Muster: PDPS (Polen)
SZD-50-3 "Puchacz"

AD der ausländischen Behörde:
GICA AD SP-0052-2003-A vom 22.07.2003

DYREKTYWA ZDATNOSCI - AIRWORTHINESS DIRECTIVE
Nr SP-0052-2003-A

MANDATORY BULLETIN
No BE-052/SZD-50-3/2003 „PUCHACZ”

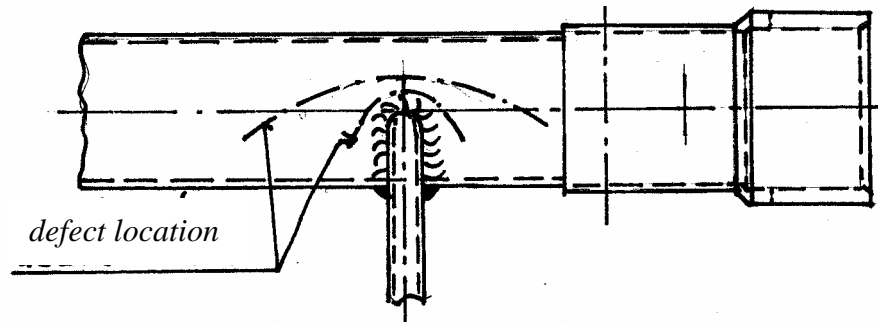
- 3.2.5. take the torque tube out from the fuselage, raising it up-, and fore.
- 3.3. Check the condition of torque tube in the area of welded joint with lever (see sketch):

- 3.3.1. check with reading glass of 3x magnifying power, at minimum, if cracks of weld or tube in the area of welded joint can be found.
- 3.3.2. check if permanent distortions to cylindrical shape of tube can be found
- 3.4. Check if inside the torque tube, especially in the area of welded joint, any evidence of corrosion can be found.

- 4.1. Cracks, permanent distortions of torque tube, as well as corrosion pit on tube inner side in the area of welded joint are not permitted.

If any one of the above listed defects has been detected – tube must be replaced with new one, purchased from Allstar PZL Glider.

Tube may be used further if no one of the above listed defects appears.

- 4.2. Slight, uniform corrosive deposit should be removed with fine abrasive paper (grid 600, at minimum). If no corrosive pits are present on a surface, after application of anti-corrosive agent (e.g. FLUIDOL) can be operated further on. Replacement with new one is recommended, however.
